Service Campaign S29650: Engine Oil Specification Upgrade

REF NO: TJ 31443	ISSUING DEPARTMENT: Technical Service		ARKET: s and Canada
3 US 7	PARTNER: 7510 Volvo Car USA	ISSUE DATE: 2016-03-22	STATUS DATE: 2016-03-24
FUNC GROUP: 2100	FUNC DESC: Engine	Page	1 of 9

# Volvo Car Customer Service QB Instruction VCC-489268-1

Title	Decal	Page	1 ( 3 )
Action	Replacement	Operation number:	98600-2

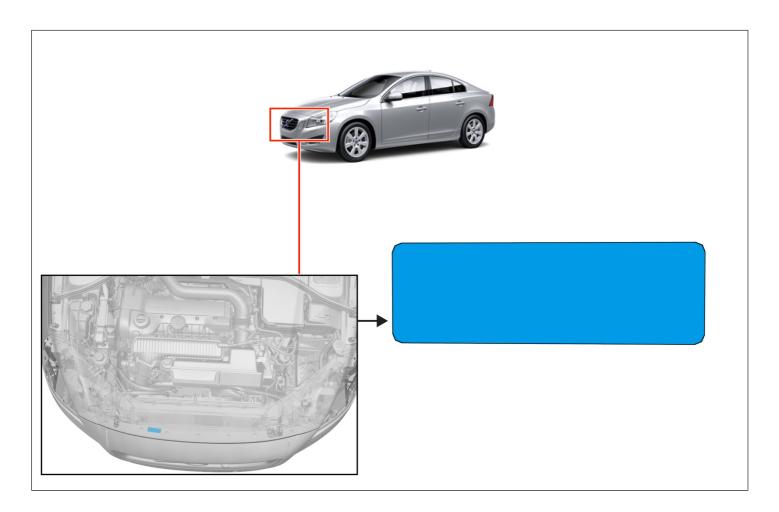
Caution! Make sure that the surface is clean and free of foreign material.

Fit the decal.
